## Product Change Notice (PCN)

PCN Number: **PCN-0451088R-01**

Product(s) Affected: **PJ-040-SMT-TR**

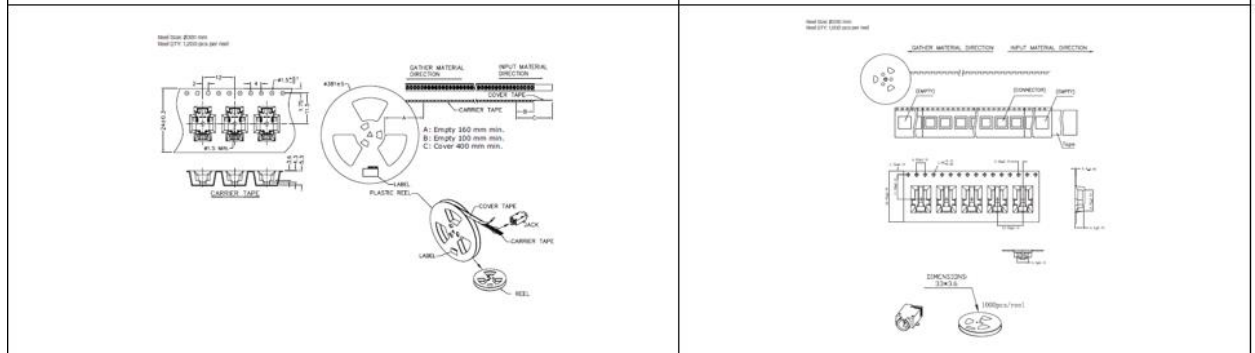
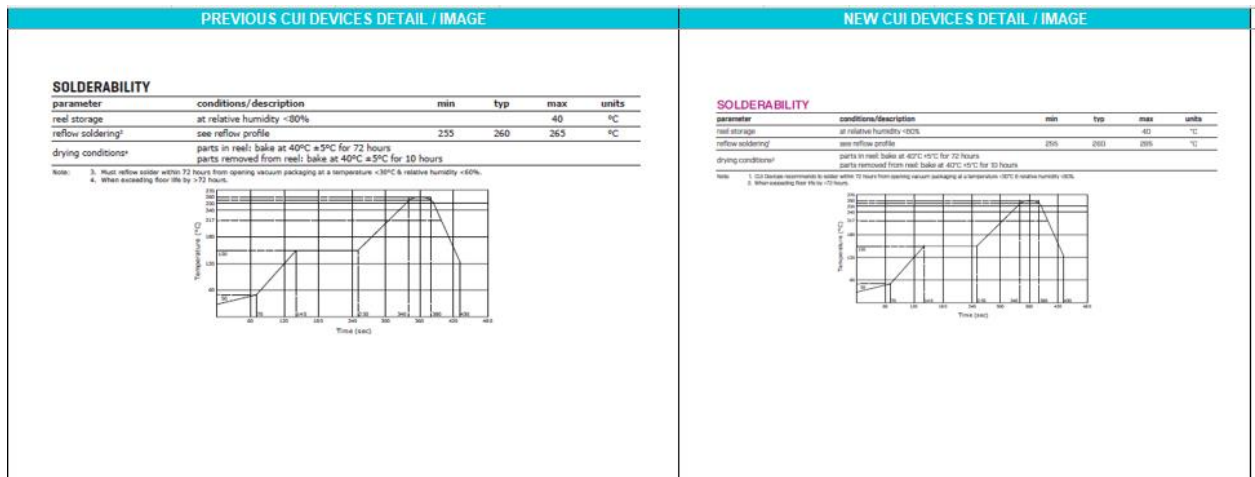
Description of Change: **Minor Housing and footprint differences. Material Change on the housing and terminals. See image Below**

MATERIAL	PLATING
center pin	copper	nickel
terminal 1	brass	silver
terminal 2	copper alloy	silver
terminal 3	copper alloy	silver
plastic	PA6T or equivalent

DESCRIPTION	MATERIAL	PLATING/COLOR
center pin	bronze	silver
terminal 1	bronze	silver
terminal 2	SUS301 t-0.20 mm	gold
terminal 3	SUS301 t-0.20 mm	gold
housing	PA10T (UL94V-0)	black
